# UNITED STATES PATENT AND TRADEMARK OFFICE

APPLICATION NO.	FILING DATE	FIRST NAMED INVENTOR	ATTORNEY DOCKET NO.	CONFIRMATION NO.
10/786,424	02/25/2004	Kenneth S. Collins	306 D13	2804

**Office Action Summary**

## **DETAILED ACTION**

**Fig. 2**

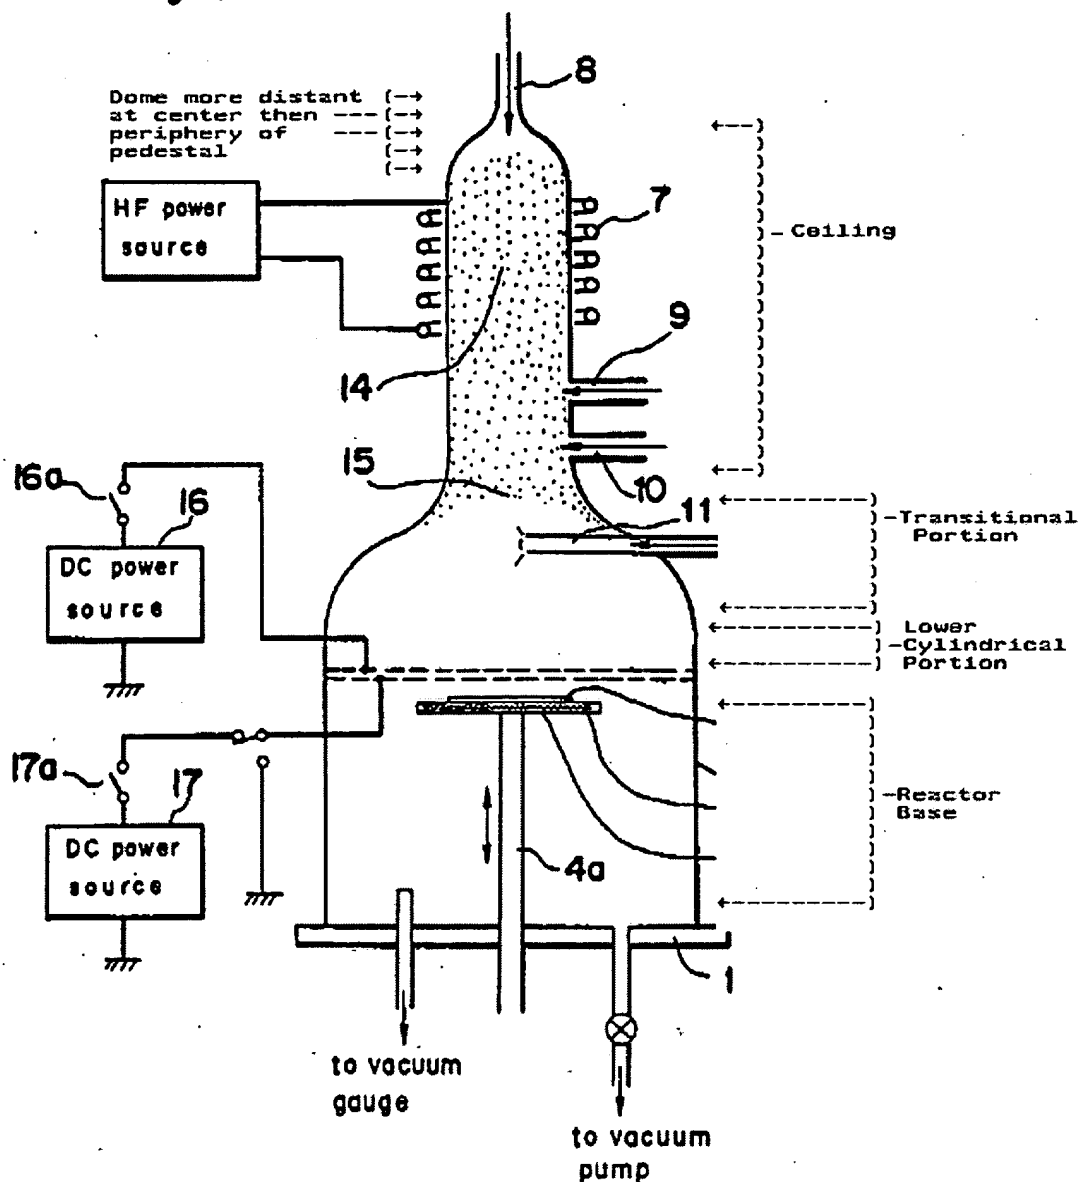
Regarding Claims 1, 2, 10, 11, 22, 23, 25 and 26, Hotomi teach in Fig. 2 a plasma chamber. (See Fig. 2) The plasma chamber includes a pedestal 4, which is adapted to hold a workpiece 3 to be processed. (Column 9 lines 65-68) A reactor base including base plate 1 houses the pedestal. (Column 9 lines 60-61; the reactor base includes the area between the grid and the base plate 1.) A high-frequency coil 7 is arranged adjacent the reactor and inductively couples power into the reactor. (Column 10 lines 11-17) The plasma chamber enclosure structure includes a bell jar 2. (Column 10 lines 60-64) The bell jar 2 is single walled. (See Fig. 2) The enclosure structure is inverted cup shape in configuration. (See Fig. 2) The plasma chamber structure includes a ceiling. (See Figure 2) The plasma chamber enclosure has a central gas inlet 8. (Column 10 lines 18-19) The plasma structure has a sidewall. (Fig. 2) The plasma enclosure has a lower cylindrical portion generally transverse to the pedestal. (Fig. 2) There is a transitional portion between the lower cylindrical portion and the ceiling. The transitional portion extends inwardly from the lower cylindrical portion and comprises a radius of curvature. (See Fig. 2) See Annotated Figure below.

The plasma chamber enclosure structure covers the base. (See Figure 2) A plasma processing volume is 14, 15 defines a plasma-processing volume over the pedestal. (Column 11 lines 68; Column 12 lines 1-5) The plasma chamber enclosure is capable of transmitting inductive power through the enclosure from an antenna. (Column 10 lines 12-17)

As seen above Yoshihiro teach a truncated cone having a flat portion where the flat portion of the cone extends to the central gas inlet. Hotomi teach applicant's required lower cylindrical portion, a portion that connects the cylindrical portion to the ceiling and the portion having a radius. Yoshihiro teach truncating the ceiling to have a flat portion. (See Hotomi discussed above and Yoshihiro discussed above)

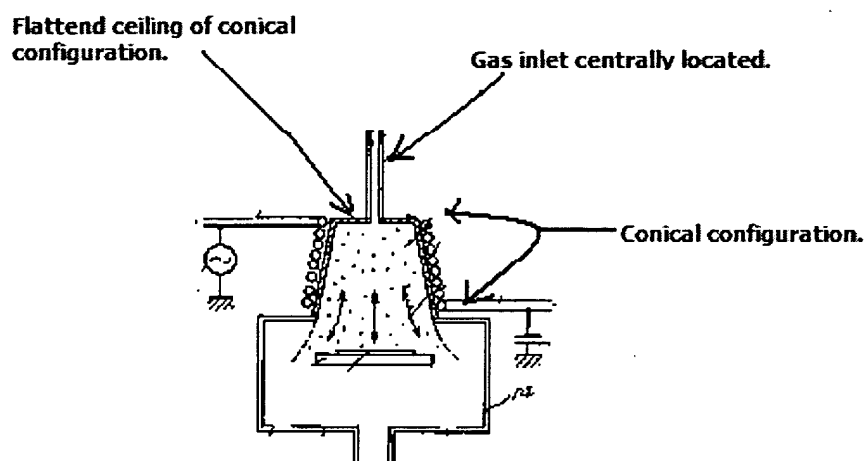
The drawings are objected to under 37 CFR 1.83(a). The drawings must show every feature of the invention specified in the claims. Therefore, the portion connecting the lower cylindrical portion and the ceiling extending inward from the cylindrical portion where the portion extends inward having a radius of curvature must be shown or the feature(s) canceled from the claim(s). No new matter should be entered.

Applicant has removed the terminology of "transitional" and "transition" to try to overcome the Examiner's objection to the drawings. However the Examiner maintains that the portion connecting the lower cylindrical portion and the ceiling extending inward from the cylindrical portion where the portion extends inward having a radius of curvature is not shown. The Examiner requests that this be shown in the drawings or pointed out in the Drawings. The drawing in Applicant's specification that has a flattened conical configuration is shown in Fig. 4E.
